HPAC Committee Agenda

PLANNING ACTION: PA- TI-2023-00216

SUBJECT PROPERTY: 263/265 Sixth Street

Planning Application for a third unit at 265 6th St.

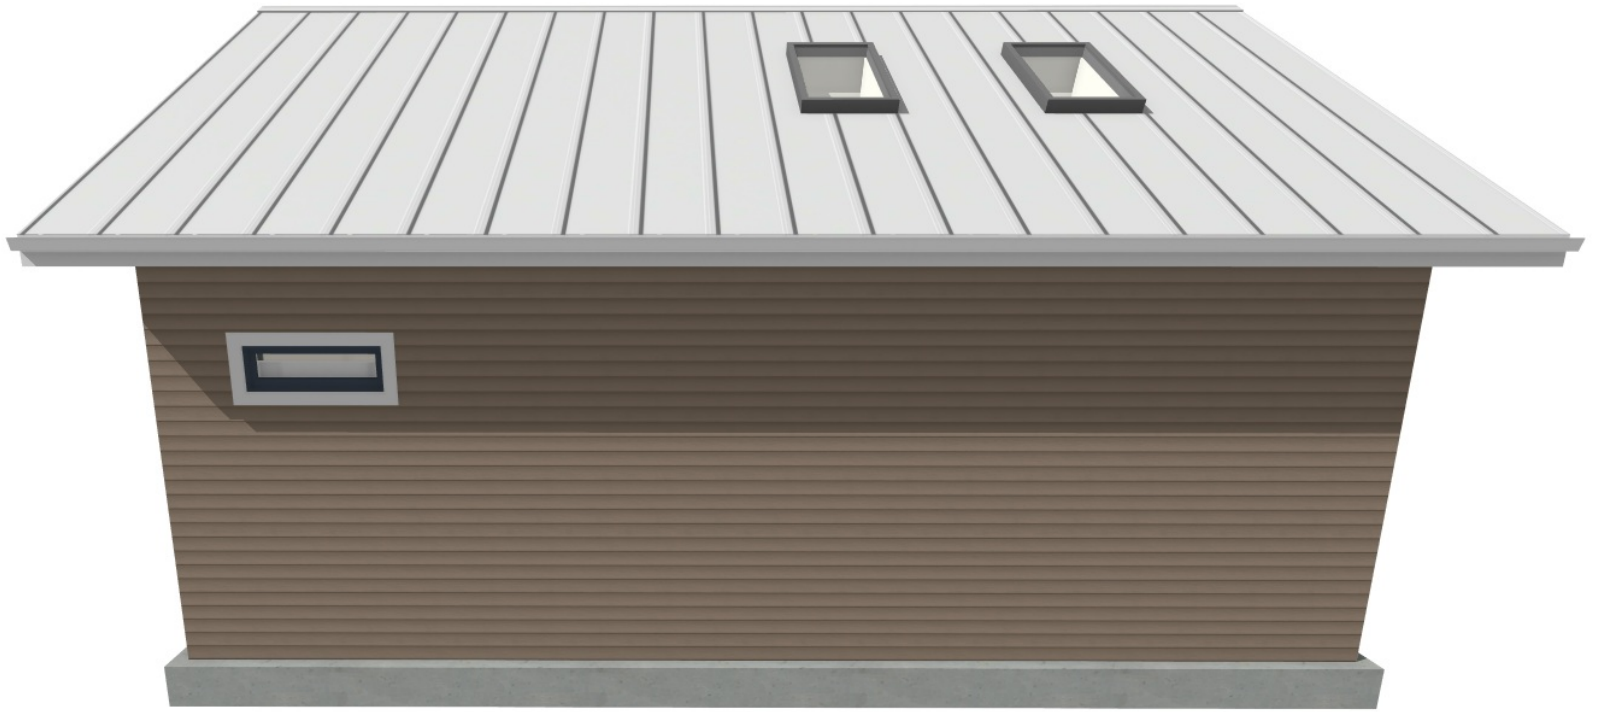
Discussion – The area to the east of the proposed third unit will be designated as Open Space. It is required to be greater than 8% of the lot size which equals 777sf. The amount labeled Open Space on the plans provides 1012sf.

Discussion – The minimum building separation required for the two adjacent buildings is 5 feet. The new unit will be built 10 feet away from the existing building.

Discussion – The setback requirements are cut in half for this particular unit and therefore the building will be within the allowed distance.
